## ASSESSMENT REPORT

### Orica Ammonium Nitrate Facility, Kooragang Island Section 75W Modification Flares and Nitric Acid Tank (08\_0129 MOD 2)

*Figure 2 – Individual Fatality Risk – MOD 2*

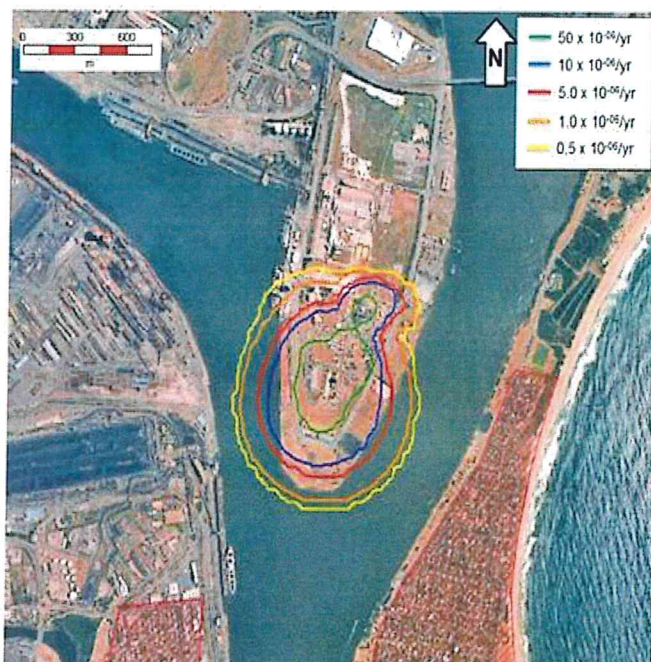
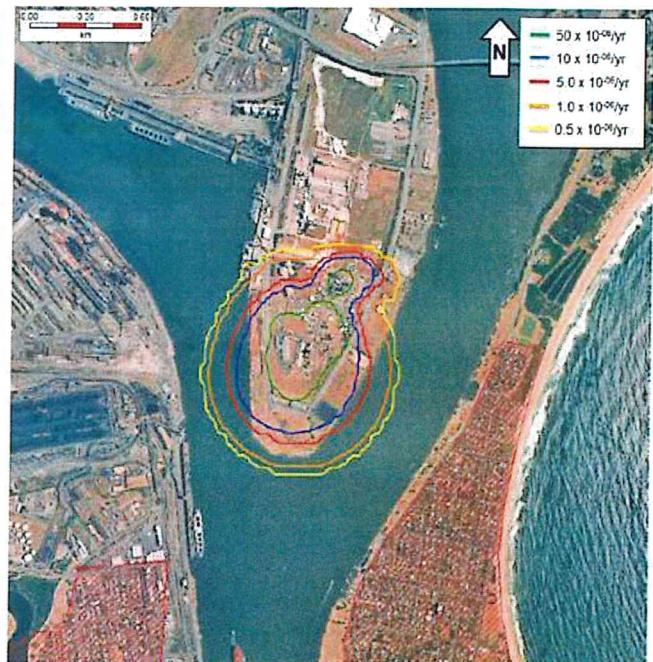
Compared to the risk profile of MOD 1, the individual fatality risk contours remain largely unchanged as shown in *Figures 1 & 2*. Notably, the 50 chances in a million per year fatality risk contour from the facility (of relevance to industrial land use) remains within the boundaries of the site, as shown by the green contour in *Figure 2* below.

Figure 7 – Toxic Irritation Risk Close-up – MOD 2

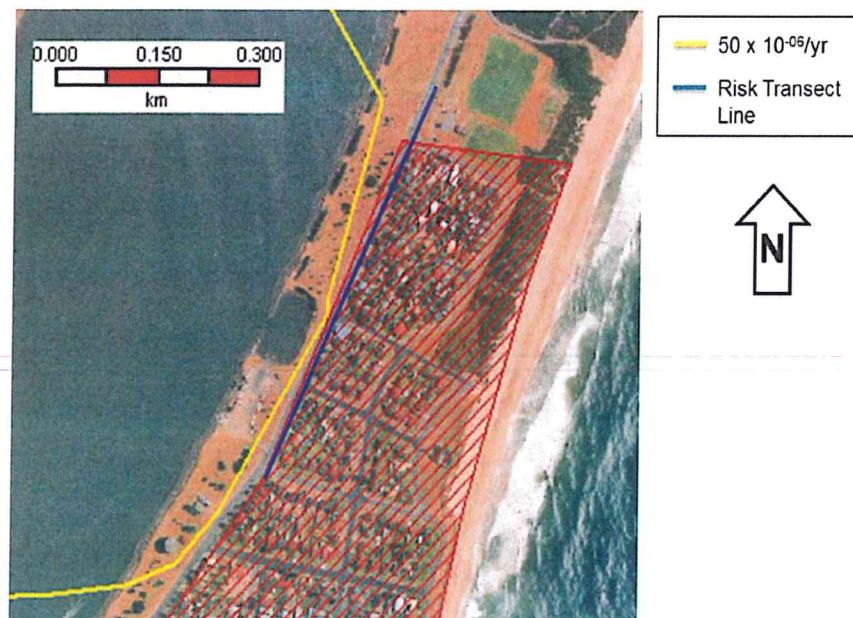
Conversely, the toxic irritation risk contours in *Figures 5 & 6* show that the risk of irritation has marginally increased. This is mainly due to the installation of additional ammonia piping necessitated by the proposed design improvements aimed at simplifying the ammonia distribution network (see section 1.4). Although slightly increased, this risk still complies with the Department's relevant land use safety risk criterion for toxic irritation risk of 50 chances in a million per year at residential and sensitive land use areas. The toxic irritation risk contour extends across the foreshore onto Stockton peninsula and skirts Fullerton Street, however it does not encroach onto any residential property (refer to *Figure 7*).

Figure 9 – Societal Risk – MOD 2

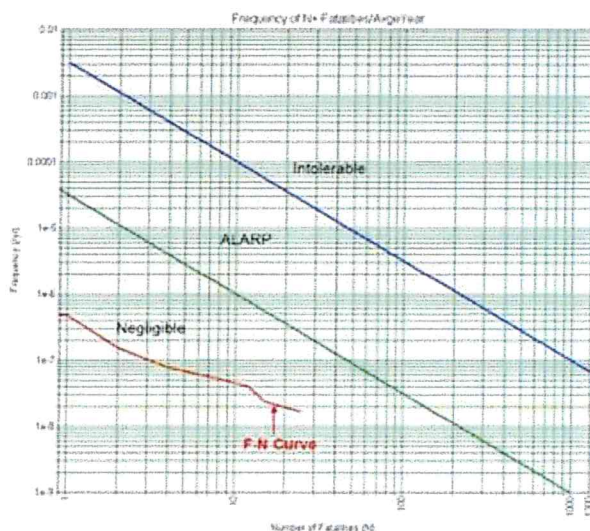
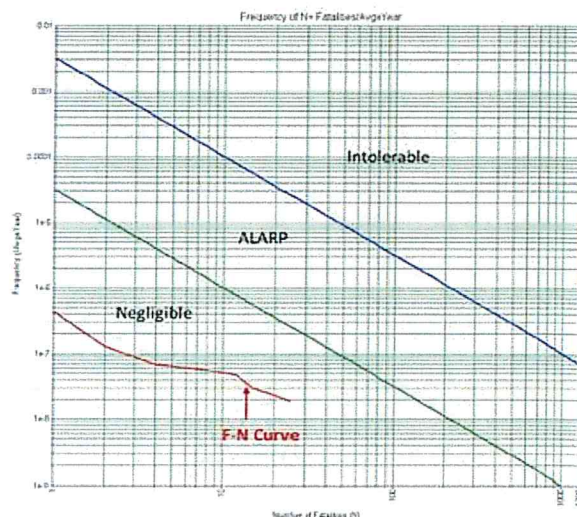
The societal risk remains unchanged, as shown in the FN curves (relationship between cumulative event frequency and the cumulative severity of outcome, in this case fatality) in Figures 8 & 9. Societal risk is a measure which takes into account the fact that society is particularly averse to accidents with a potential to cause multiple fatalities. Societal risk is in the 'negligible' region. In this region, the societal risk is not considered significant provided that all other individual risk criteria are met, which is the case for MOD 2.
